**Task Order No. 3, Review of the Harris Project Application for Combined  
Operating License in the Areas Relating to Geology and Seismology**

**Harris Nuclear Power Plant Units 2 and 3**

**SSAR RAIs, Submitted by USGS, 1 August, 2008, for Harris, North Carolina site**

Figure RAI SH-1.

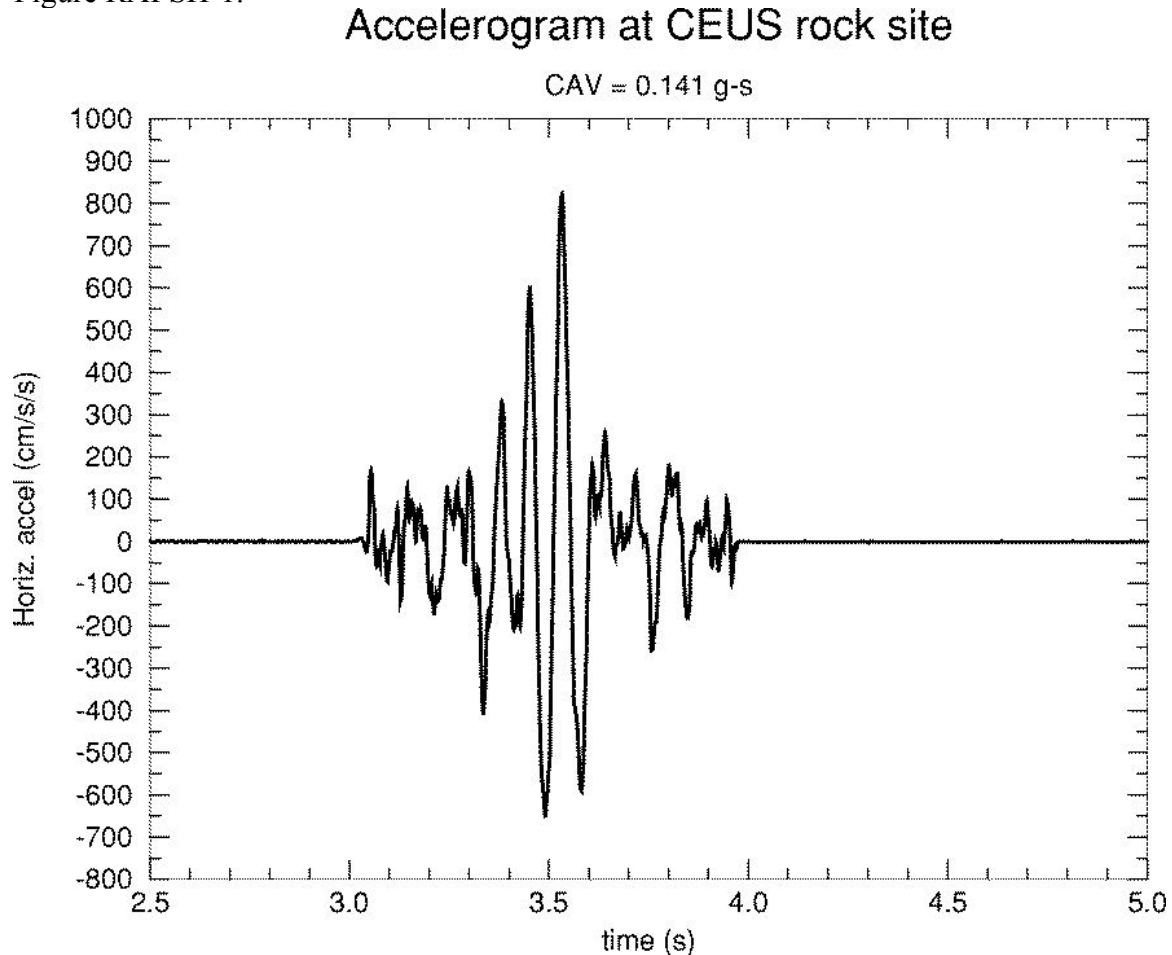
FSAR 2.5.2.5.3.4 (p. 2.5-163) uses a method which incorporates CAV to determine the sources to consider when computing the rock spectra at HAR 2 and HAR 3. Figures 2.5.2-299 illustrates the 10-hz mean hazard curves with and without CAV. The  $10^{-5}$  PE 10-hz mean SA with CAV is about 0.9 times the mean SA without CAV according to Table 2.5.2-221, and is about 0.75 times the mean SA without CAV at  $10^{-4}$  PE. The below synthetic seismogram represents the motion from a nearby small, but high stress-drop, earthquake. Its CAV is 0.141 g-s and therefore this source would be omitted from consideration when computing the GMRS by virtue of CAV filtering. Nevertheless, its 10-hz 5% damped pseudo spectral acceleration is 1.96 g, about six times the GMRS 10-hz 5% damped pseudo spectral acceleration of Table 2.5.2-222 (p 2.5-192). Please justify

the omission of sources with CAV less than 0.16 g when such sources may produce high-frequency spectral ordinates many times in excess of the GMRS spectra and greater than the high-frequency portion of the RE, DE and other spectra to be used in seismic-resistant design at HAR2 and HAR3.
